Range H&C - HO.RE.CA.	Model KREA ES/FB - 9100	N° T.I. 02_2016
Serial Number 60211125	Subject Z4000 ES/FB Upper piston O-Ring housing modification	N° Claim -

New Z4000 ES/FB Upper Piston

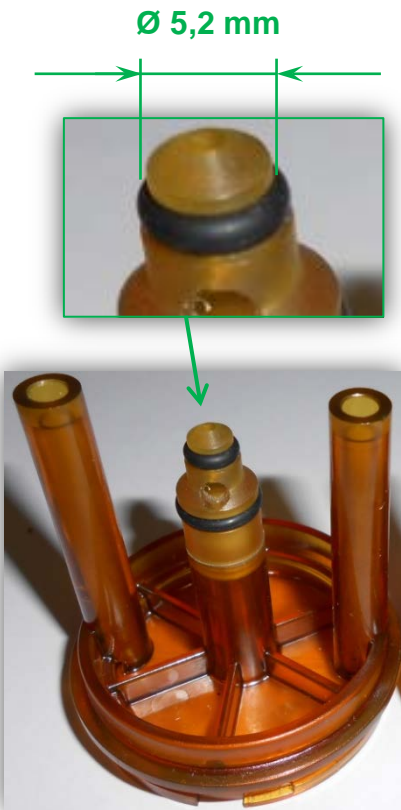
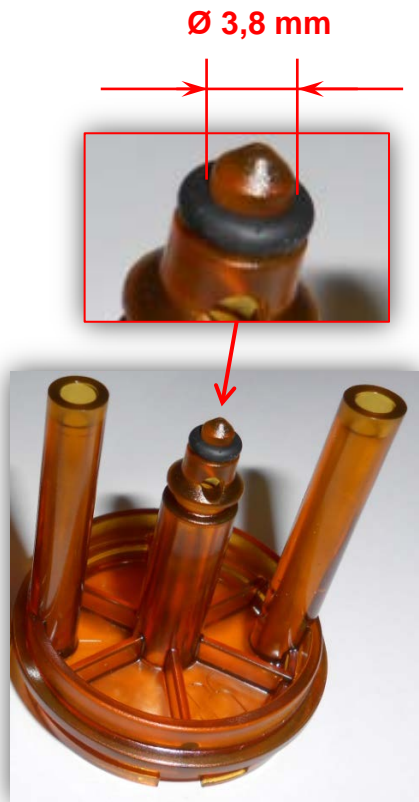
With the aim to improve our equipment, starting from S/N **60211125**, the *Z4000 ES/FB top piston O-Ring housing* has been modified.

Modification: the *OR housing retaining side* has been increased of 1.4mm (moving from $\varnothing 3,8$ mm to $\varnothing 5,2$ mm - see picture below).

The new housing shape guarantees a better OR stability preventing untimely wear and possible malfunctioning.

The **new** upper piston spare code is: **260204**

The **pre-modification** upper piston spare code is: **256750**
It is no longer available
